Service Bulletin

S027

SUBJECT: **Product Safety Recall.** Honeywell Fan Timer Board, ICP Part Number 1084197, when used in certain 10 SEER Entry Level Gas/Electric Packaged Units.

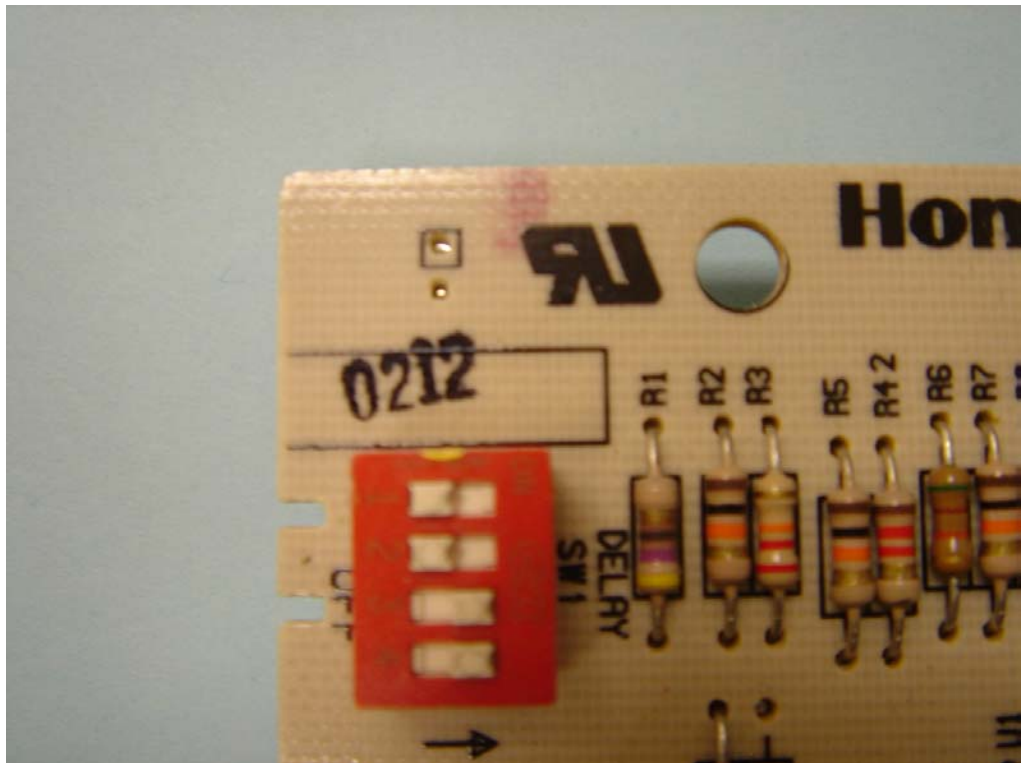
If you encounter a unit that you think may already have had a new board installed, you can confirm by checking the date code on the board. Only fan control boards with a Honeywell date code of 0429 or older must be replaced. This date code marking is located on the corner of the fan control adjacent to the fan time on/off DIP-switch. Fan Controls with a date code of 0430 or newer have the new revisions and do not need to be replaced. Such units must be reported to ICP for tracking purposes. An example of this date code is shown in the picture below with a 0212 date code.
